Product Change Notification

No. 028-21

TRACO POWER TEN 40E and TEN 40WIE series

Base plate preparation for additional heatsink mounting options

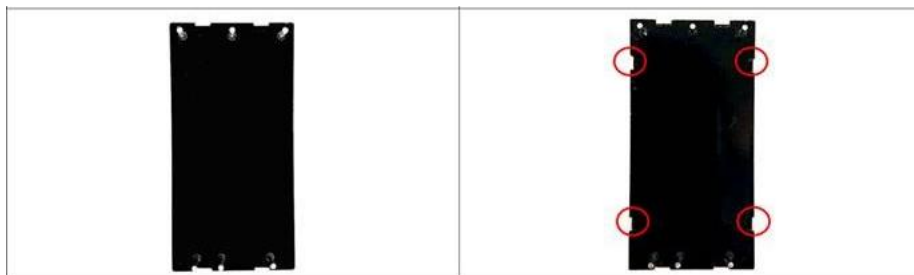
Subject product series have undergone a minor package design change. To be able to mount additional heatsink options the base plates of the TEN 40E and TEN 40WIE now received four additional slots for mounting clamps on the long sides.

Phased out package design

New package design

The exact positions of the new slots can be seen on the updated 3D-files online on our website: www.tracopower.com/overview/ten40wie
